Retail Conversion Grant APPLICATION

ARCHITECTS RESPONSE TO PLAN REVIEW

520 MAIN STREET VANILLA SHELL RESUBMITTAL
LONGMONT, COLORADO

MECHANICAL DEMOLITION AND NEW WORK PLANS

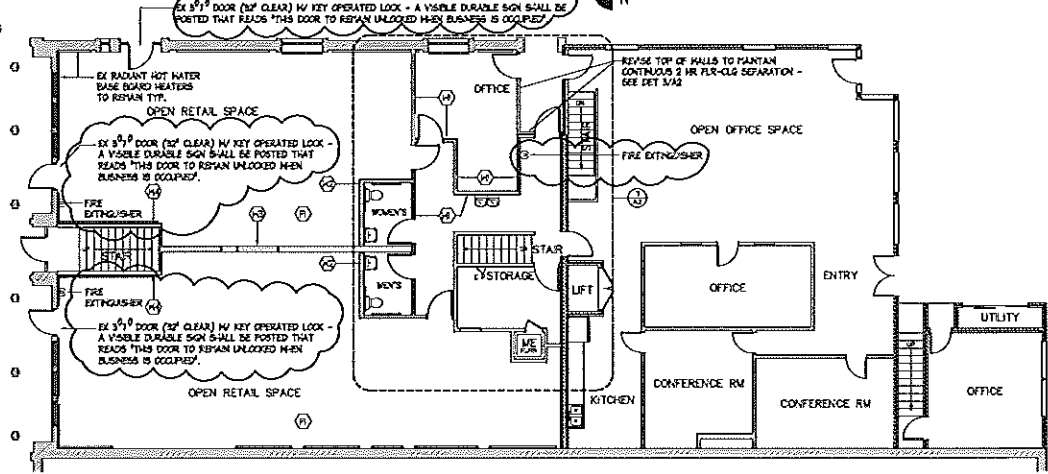
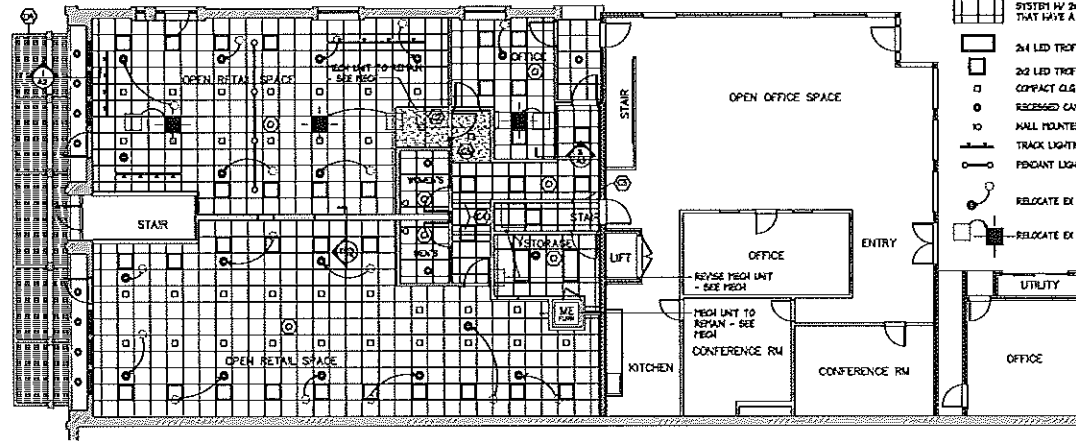
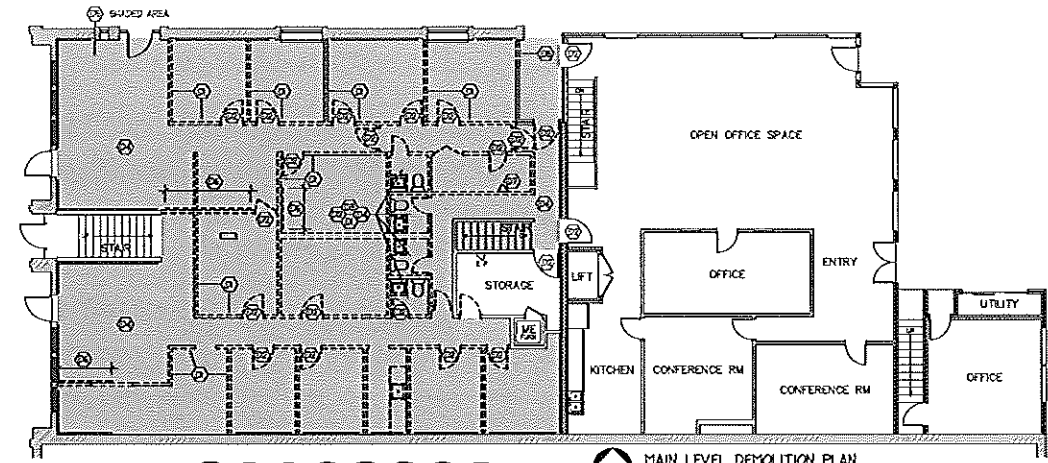
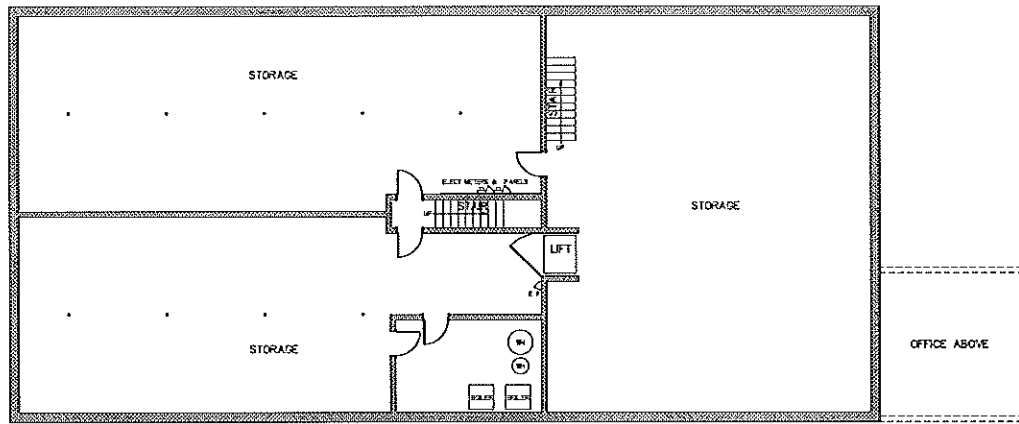
7. Please note; corridors shall be fire-resistance rated in accordance with IBC table 1020.1. The corridor walls required to be fire-resistance rated shall comply with section 708 for fire partitions. Please note that all doors within the corridor will need to be rated per table 716.5 and be self-closing; in addition any openings/penetrations (doors, fire dampers, etc.) will need to comply with 708.6 and 708.7. Please revise drawings and indicate the exact wall listing (UL or GA listing), fire damper locations, and detail(s) associated with this requirement including how penetrations (fire stopping, etc.) will comply with these sections. The owner & GC shall coordinate all door & hardware selections based on the egress requirements stated in the revised door keynotes on Sheets A1 & A2. A note has been added that "fire dampers shall comply with 2015 IBC 708.6 and 708.7." See revised sheet M1.1.

JOB NO. _____
SHEET NO. **A1**

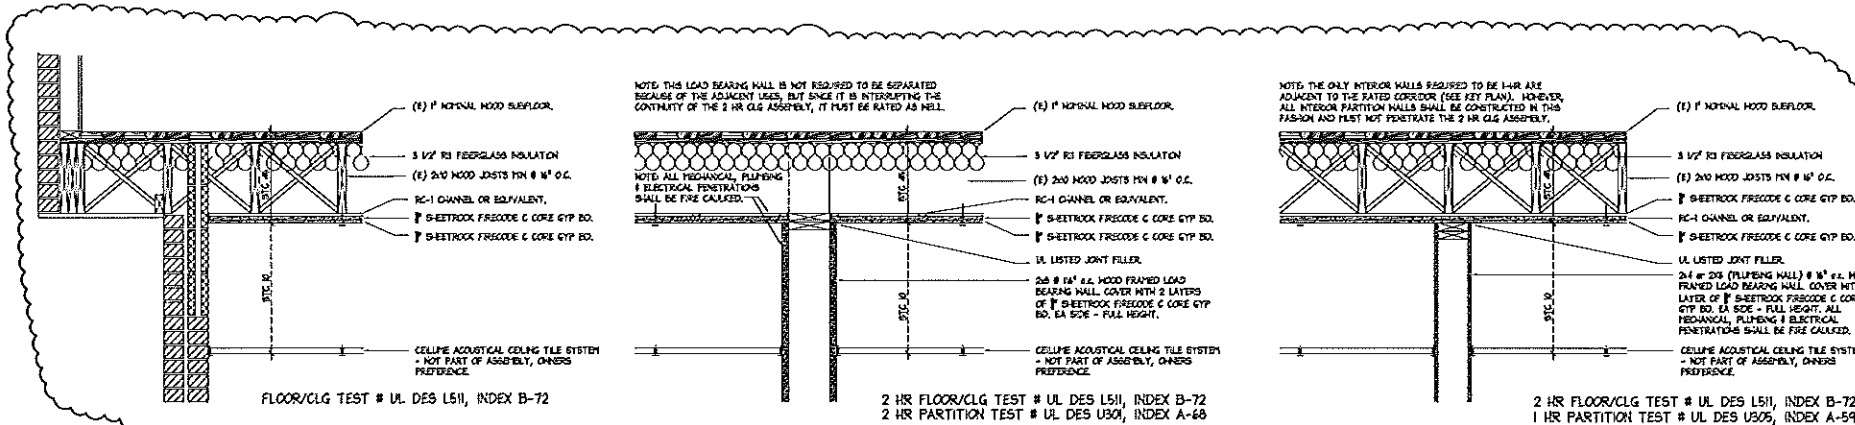
2. Please indicate on the drawings if this building is sprinklered or not. In addition, I would suggest using spell check on the notes of the drawings to make sure the correct wording is used, so no misinformation may affect the outcome of the project. The building shall not be sprinklered as indicated on the code review on page A1 of the drawings.

3. The occupant load information will need to be revised with the following information; under the title it shall state gross not net, all conference rooms shall use an occupancy factor of 15 (when the room has table and chairs) not 100, the occupant load factor for mercantile shall be 60 not 30, and the basement storage area shall also be included (you can use an occupancy factor of 500 if only using it for storage). Please note this revised occupant load total shall be used to determine the plumbing fixture count (not how it was calculated on the drawings). After doing a preliminary calculation, I do not believe you met the minimum requirements. The occupant load information has been revised based on these numbers. Refer to the code study on page A1 of the drawings.

5. It was not clear to me if the existing stair enclosure from the second floor to the exterior (west side) maintains the continuity of a 2-hour separation/protection from the adjacent tenants. Please verify compliance. The stair enclosure shall maintain the continuity of a 2-hr separation between the Residential & Mercantile. See the revised Key Plan on sheet A1.

15. Per our fire department; 2A-10BC fire extinguisher shall be installed in both tenant spaces near exits. Fire extinguishers were added at 3 locations. See revised Main Level Floor Plan Sheet A1

1 2 HR FIRE-RATED ASSEMBLY DETAIL
1/4" = 1'-0"

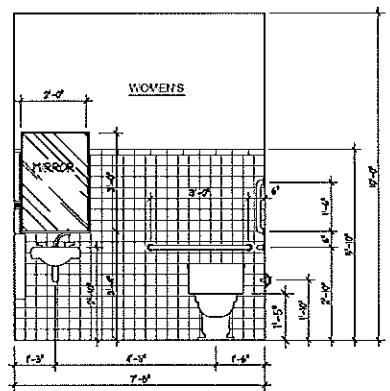
I have determined that an additional STC of 10 can be added to the assembly by installing Ceilume, an acoustical ceiling tile system beneath the L511 assembly (see attachments). Although there is no UL rating for this type of assembly, based on my research the combined systems add up to an STC of 55, which is better than the IBC requirement of 50. See revised details 1-3 on sheet A2.

7 ENLARGED FLOOR PLAN
1/4" = 1'-0"

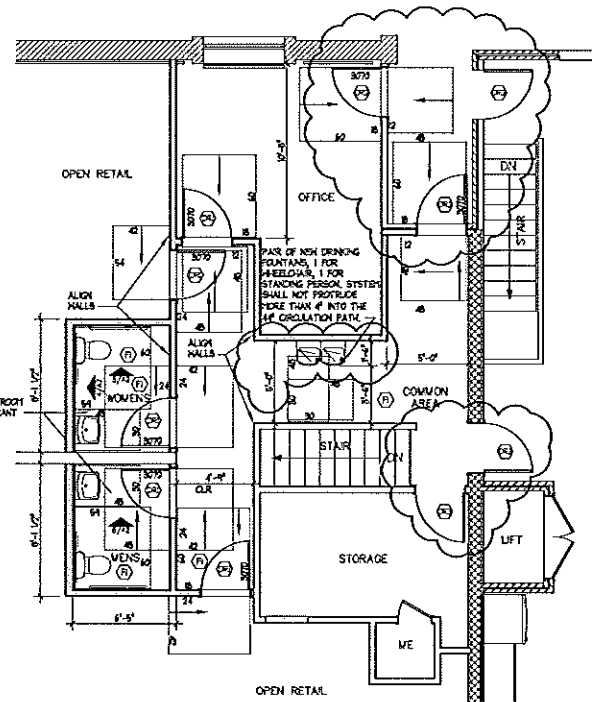
6. The drawings did not provide any hardware information. At a minimum please provide the following information; how each means of egress door complies with IBC section 1010.1, the required fire rating when applicable (shall be self-closing), how each doors complies with 2009 ICC/ANSI A117.1 section 404 and 404.2.3.2. for door clearance. The owner & GC shall coordinate all door & hardware selections based on the egress requirements stated in the revised door keynotes on the Sheets A1 & A2. All ANSI required door clearances are shown on the enlarged floor plan 7/A2.

9. The new drinking fountain protrudes more than 4" into the circulation path. As required per 2009 ICC/ANSI A117.1 section 307 and 602 no drinking fountain shall protrude 4 inches maximum horizontally into the circulation path. Also per IBC section 1020.2 the minimum corridor clear width shall be 44". Please verify compliance. This issue has been resolved by widening the corridor to 5'. See revised enlarged plan 7/A2.
